Re: Comments on April 2025 Salinas Valley Historical Benefits Analysis Update and May 29, 2025,
Draft Interlake Tunnel and San Antonio Spillway Modification Assessment Engineers Report

To: Nancy Isakson, President, Salinas Valley Water Coalition
CC: Eric Robinson, Kronick Moskovitz Tiedemann & Girard
From: Dwight L. Smith, PG, CHg, Principal Hydrogeologist
Date: September 2, 2025
Subject: **Technical Review Comments on the MCWRA Historical Benefits Analysis and Draft Interlake Tunnel Engineers Report**

Figure 1-6 (HBA, 1998) of average increase in water levels elevations resulting from reservoir options from the 1998 HBA modeling.

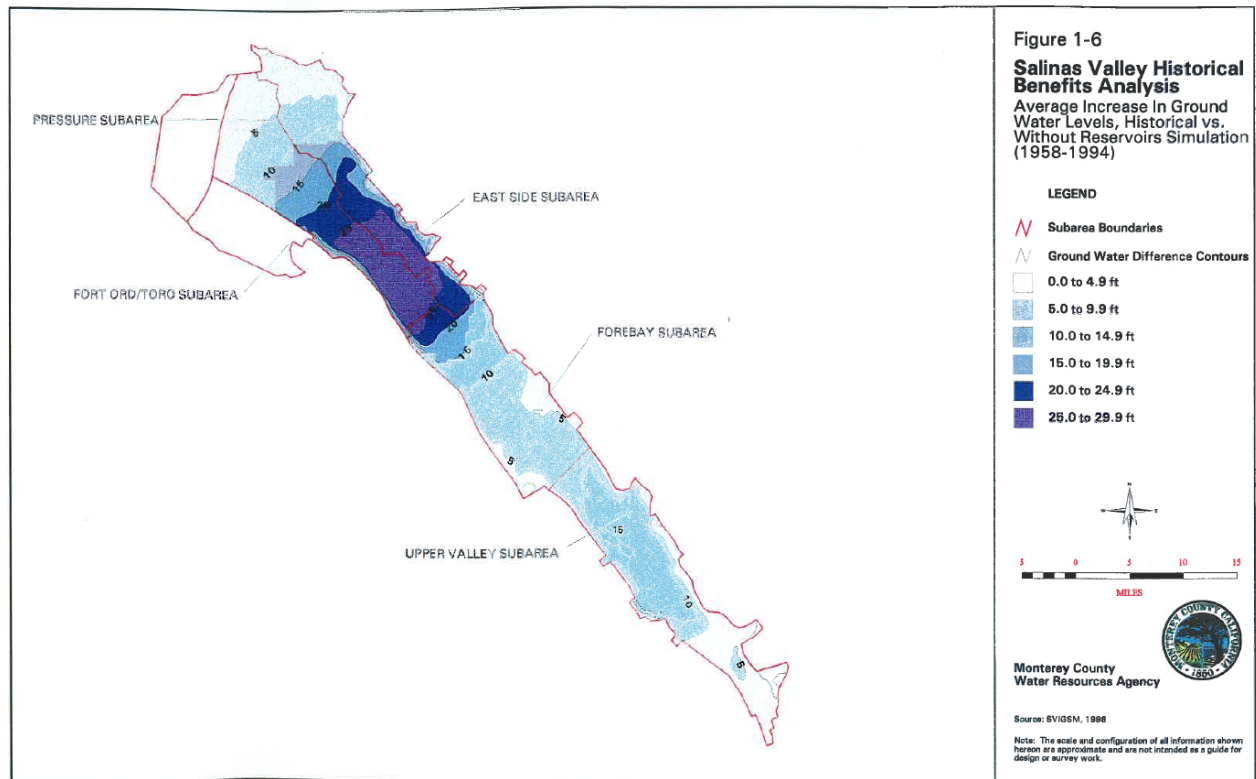
The unacceptable use of the drains in the SVIHM model version used for the HBA Update analysis is also a likely explanatory reason for the noticeably different model outcomes for predicted water level elevation changes with and without the reservoirs in the 1998 versus 2025 HBA modeling. Predicted groundwater elevation changes as a result of historical reservoir operations were notable in the southern Pressure Subbasin and north Forebay Subbasin in the 1998 SVIGSM modeling, with average water level elevation increases of 10-25 ft (see Figure 1-6 from the 1998 HBA report, included below). Over most of the Salinas Valley, the 1998 modeling indicated a 5-10 ft average water level increase. By comparison, the 2025 HBA Update modeling predicts essentially no average annual water level increase as a result of the reservoirs, with only modest increase directly along the river, and more substantial water level increases in the northern Pressure subbasin as a direct result of CSIP/SRDF. In review of available historical water level elevation data, it appears that a historical rise in water level elevations post-reservoirs (1958 for Nacimiento) as represented in the 1998 modeling is supported by the data, but perhaps of a more modest magnitude of approximately 5-15 ft (reference is made to hydrographs of water level elevations for 1948-1994 in the Appendix A to the HBA, Montgomery Watson, 1998).

The lack of predicted water level elevation responses from the reservoir operations and inconsistency with the prior body of work from the 1998 HBA modeling, which was a significantly peer reviewed effort, should have led to questioning of the validity of the results being observed in the HBA Updated modeling.
